AGENDA
CITY OF KENTWOOD PLANNING COMMISSION
TUESDAY, JULY 11, 2023
KENTWOOD COMMISSION CHAMBERS
4900 BRETON AVENUE, SE
7:00 P.M.

STAFF REPORT: June 29, 2023
PREPARED FOR: Kentwood Planning Commission
PREPARED BY: Lisa Golder
CASE NO.: 16-23 Kum and Go SLU and Site Plan Review Vehicle Fuel Station

To: Kentwood Planning Department
From: Brad Boomstra, P.E.
City Engineer
Date: July 6, 2023
Re: **Kum & Go**
2975 & 2995 28th Street SE
41-18-10-476-021 & -018
Review of Site Plan Received 6-23-2023

FIGURE 5
FUTURE TRAFFIC VOLUMES

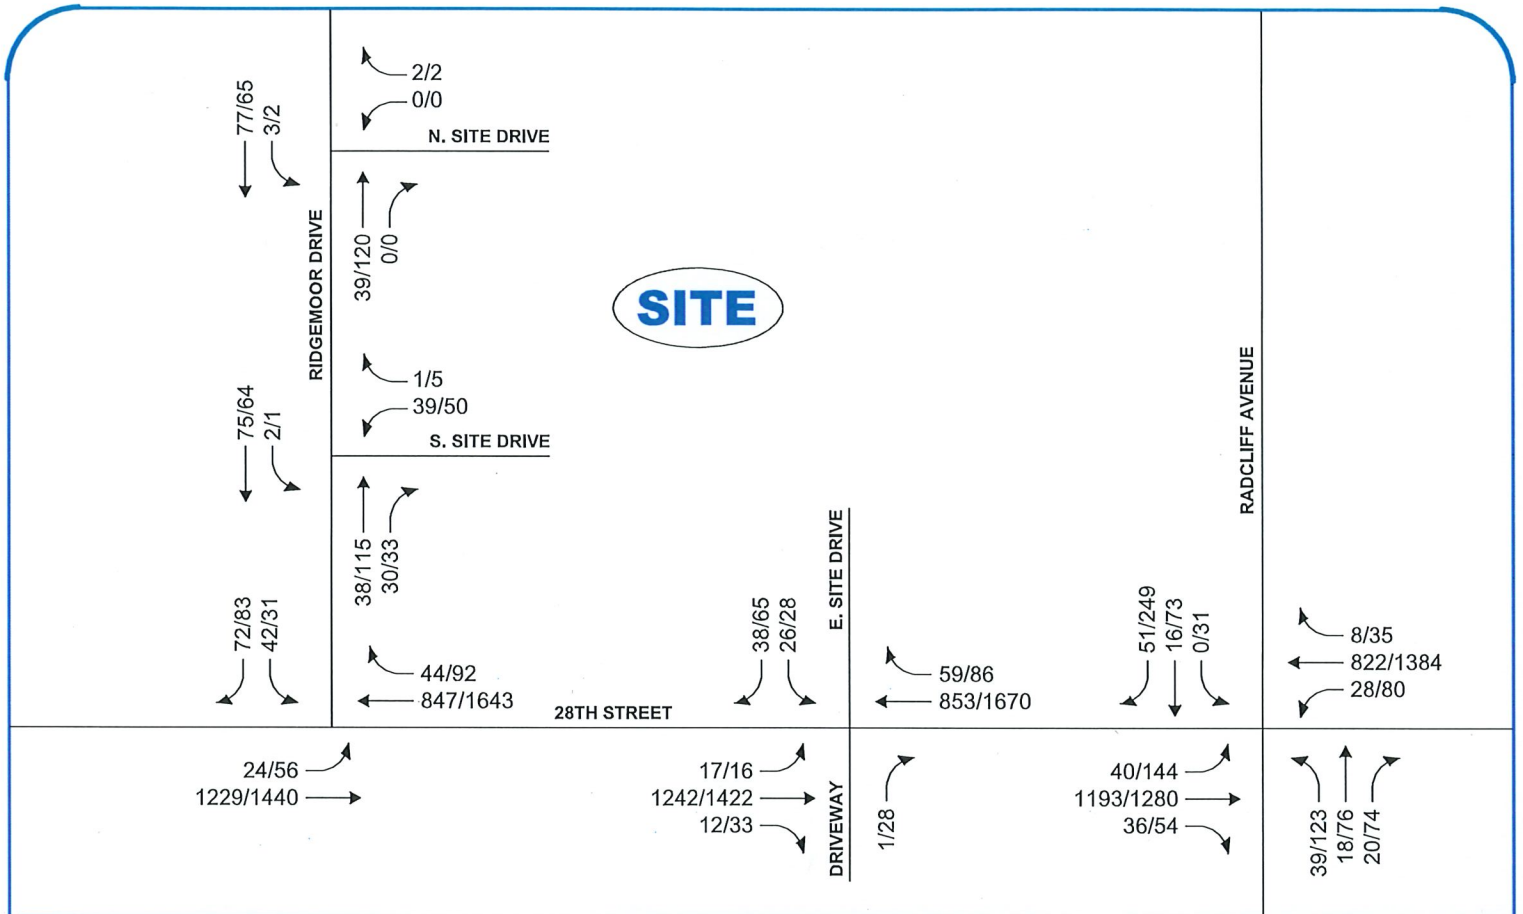
Why did this go from C to B?
The delay didn't change in either peak hour?

SHEET NUMBER:
03 OF 17

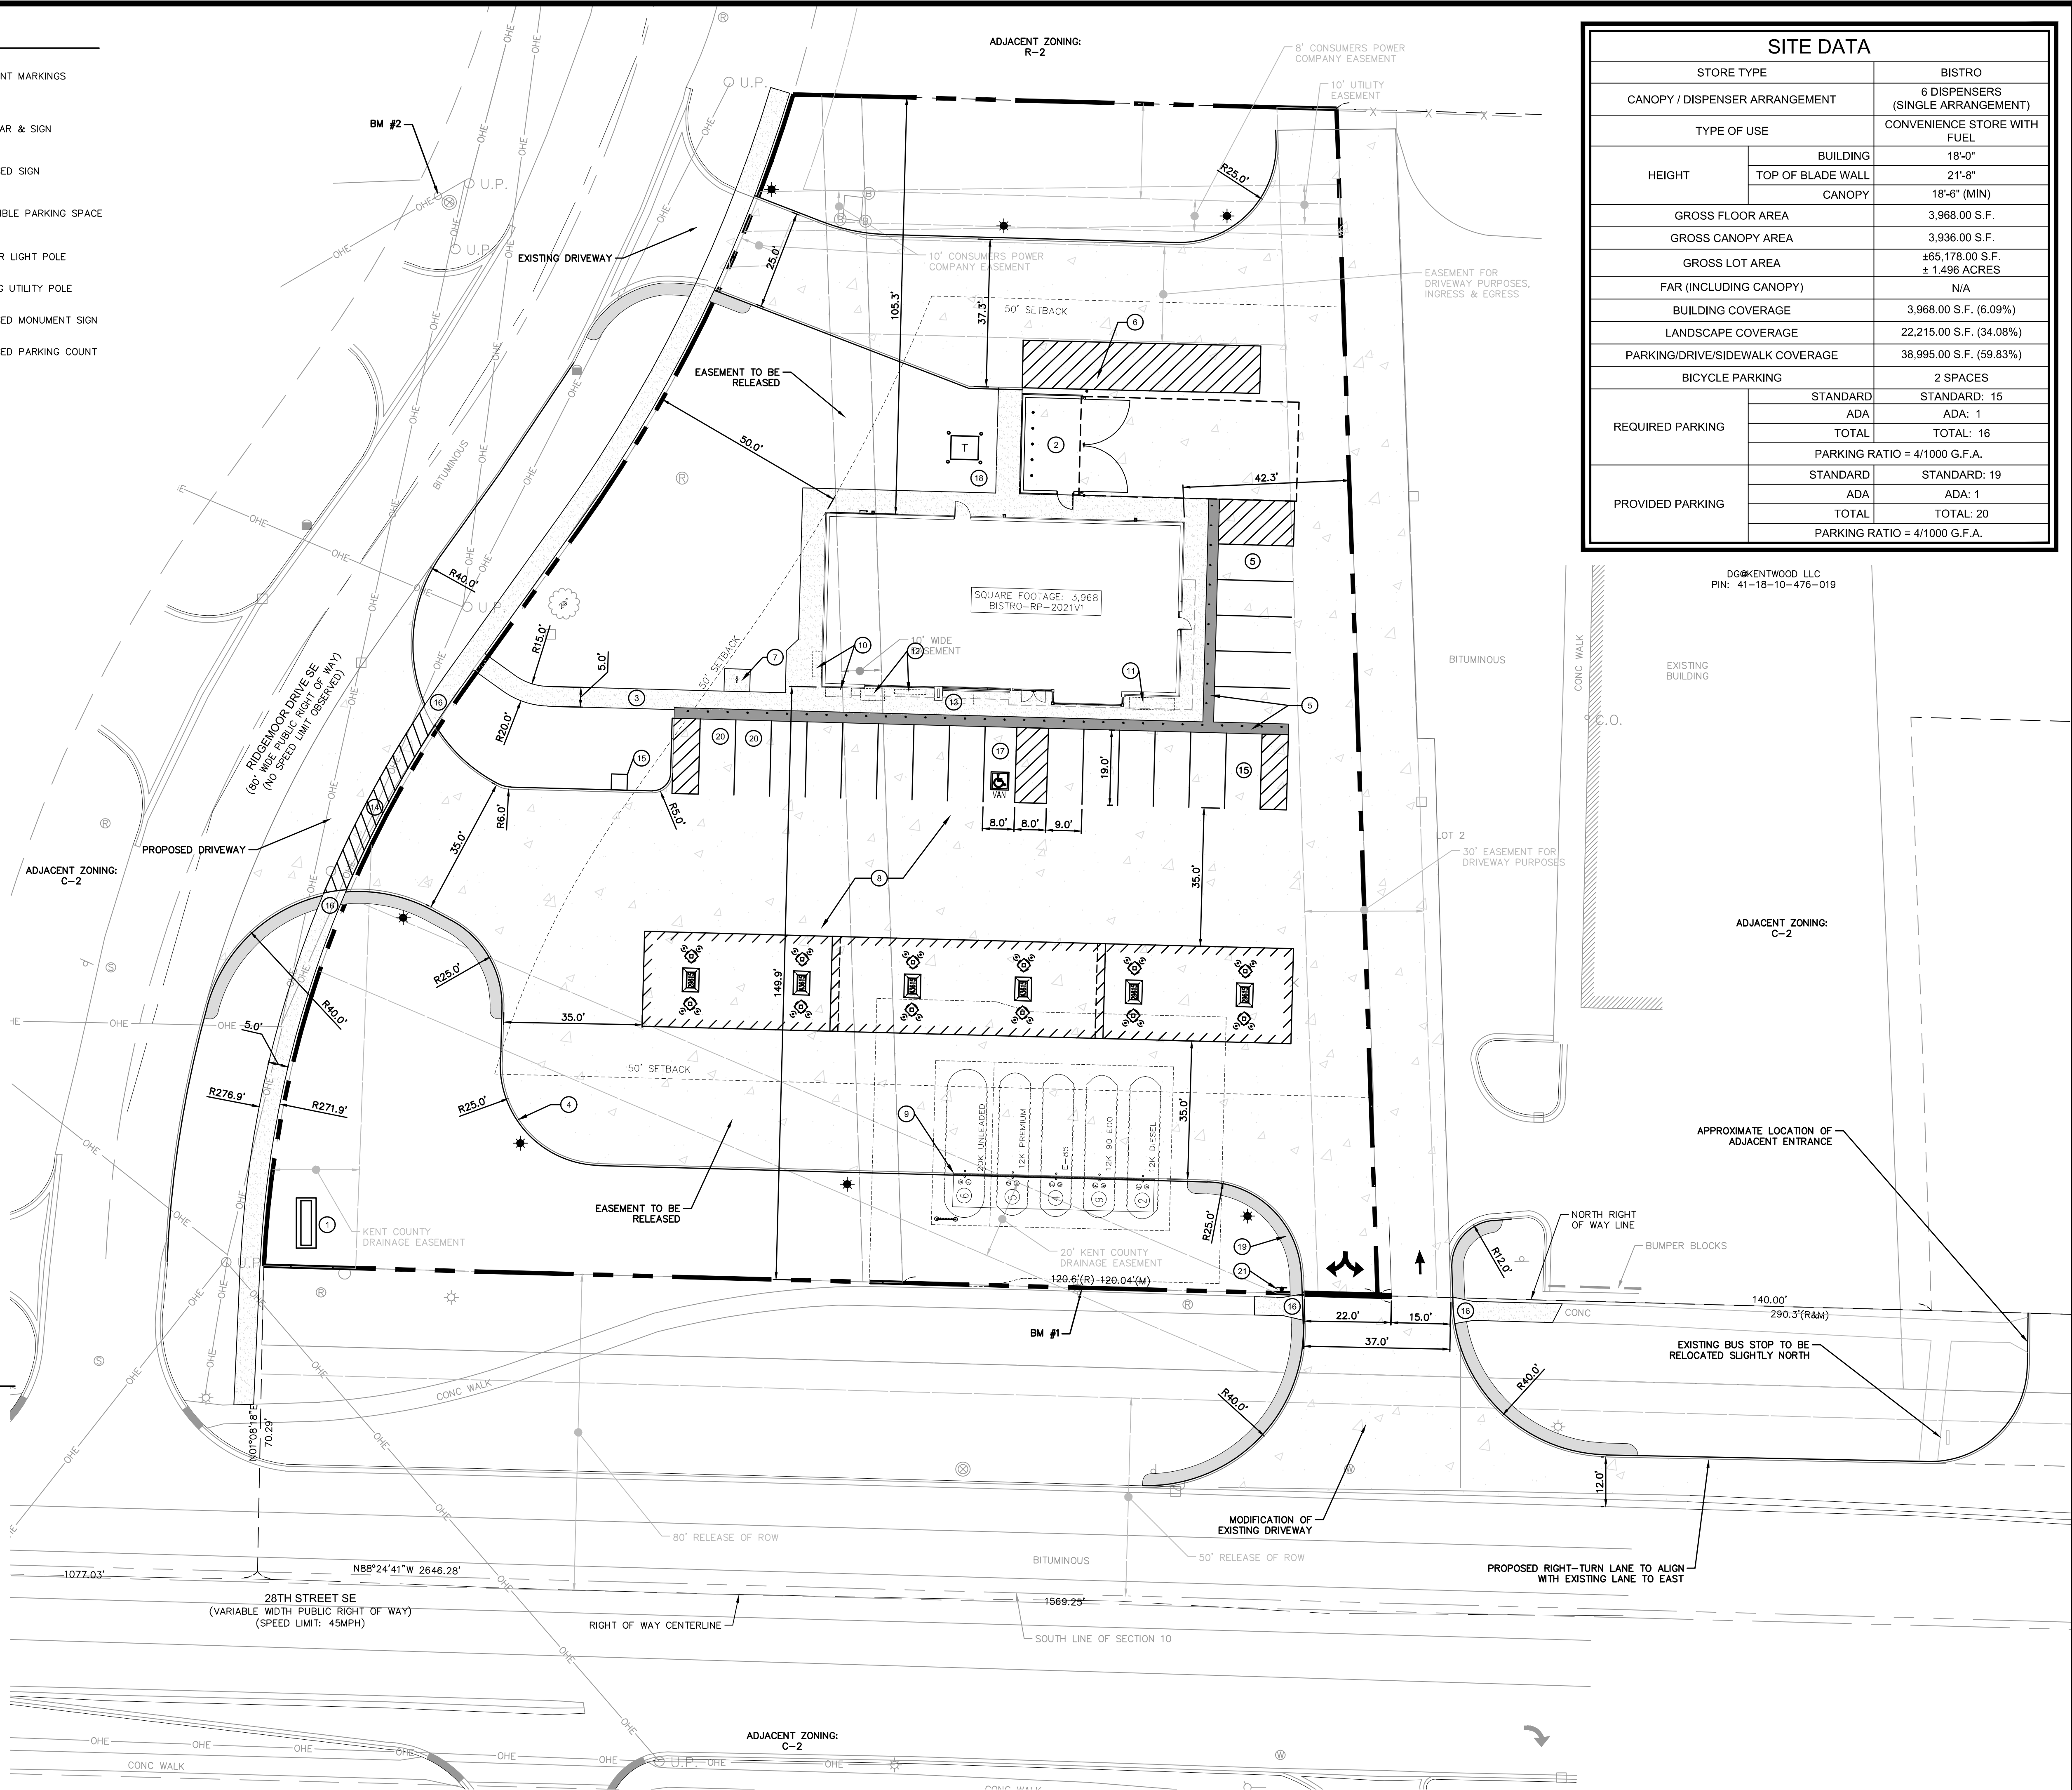
1. Concrete curb and gutter per MDOT standard plan R-30 series (Detail F4, as modified for the tilt of the gutter pan), and a commercial drive opening per MDOT standard plan R-29 series (Detail M) are required for the proposed drive approach entrance within the Ridgemoor Drive right-of-way.

2. The pavement within the commercial drive approach between the sidewalk and the gutter pan must be concrete at least 6 inches thick.
3. For any curb cut which terminates less than five (5) feet from a construction joint, the contractor shall remove and replace the existing curb to the next joint.

4. The sidewalk must be carried across the commercial drives. Where it crosses, it must be at least 6 inches thick.
5. Pavement section details must be shown on the plans for all pavement types.

6. The Michigan Department of Transportation (MDOT) has jurisdiction over 28th Street (M-11) for the proposed driveway to 28th Street.
7. Include the City of Kentwood General Notes on the plan(s). These notes are required for the work being performed in the Ridgemoor Drive right-of-way. Highway permit conditions, specifications and required general plan notes are posted on the City's website, and can be accessed at <http://www.ci.kentwood.mi.us> (hover over "CITY SERVICES" and "DEPARTMENTS" then click "ENGINEERING", then click the "RIGHT-OF-WAY" link near the top of the page).
